Shown on engine 271.940

Modification notes

Remove/install		
1	Open engine hood	Model 203 Model 209 Model 211	AR88.40-P-1000P AR88.40-P-1000Q AR88.40-P-1000T
2	Remove cylinder head cover	Model 203, 209 Model 211	AR01.20-P-5014QK AR01.20-P-5014TK
3	Remove front cover at cylinder head		AR01.30-P-5700QK
4	Rotate the engine at the crankshaft in the direction of rotation.	 until the piston of cylinder 1 is at TDC marking $\pm 2^\circ$ crankshaft angle.  The TDC marking on the belt pulley/ vibration damper must be aligned with the positioning edge on the timing case cover.  The cams of the inlet camshaft and the exhaust camshaft at cylinder 1 must be positioned up at an angle: See "Check basic position of camshafts".	AR05.20-P-6010QK
5	 Mount retainer (2)	  Install retainer (2) above recesses on top camshaft case. 	*271589006100
6	Release timing chain		AR05.10-P-7605-01TK *271589003100
7	Remove the center bolt and remove the camshaft adjusters (3) from the respective camshaft	 At the same time unhook timing chain and secure against falling down. The intake and the exhaust camshaft is slackened in the same direction (arrow).  Installation: Camshaft adjusters (3) do not require any partic

P05.20-2126-05

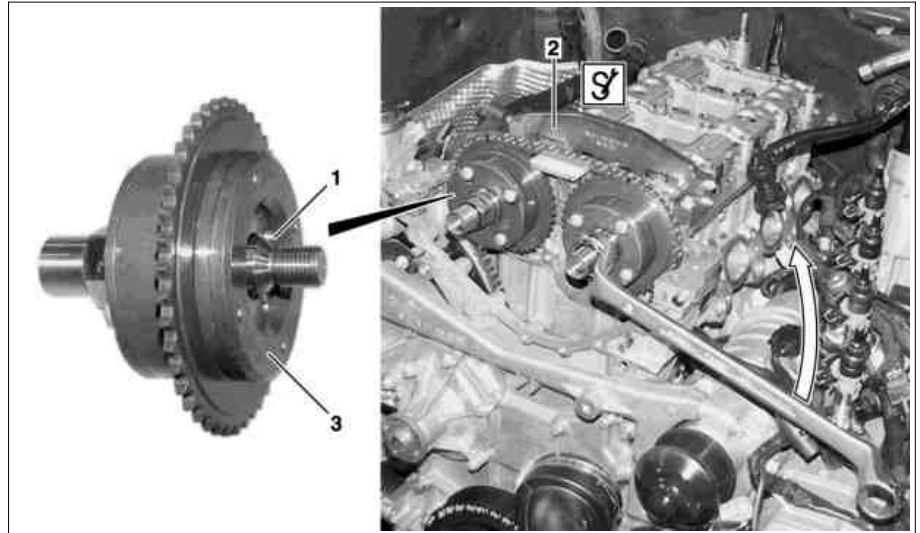
16.4.03	Change in the repair method, to release the timing chain, the chain tensioner is no longer removed, instead the slide rail in the cylinder head is pushed back	Step 5	
---------	--	--------	--
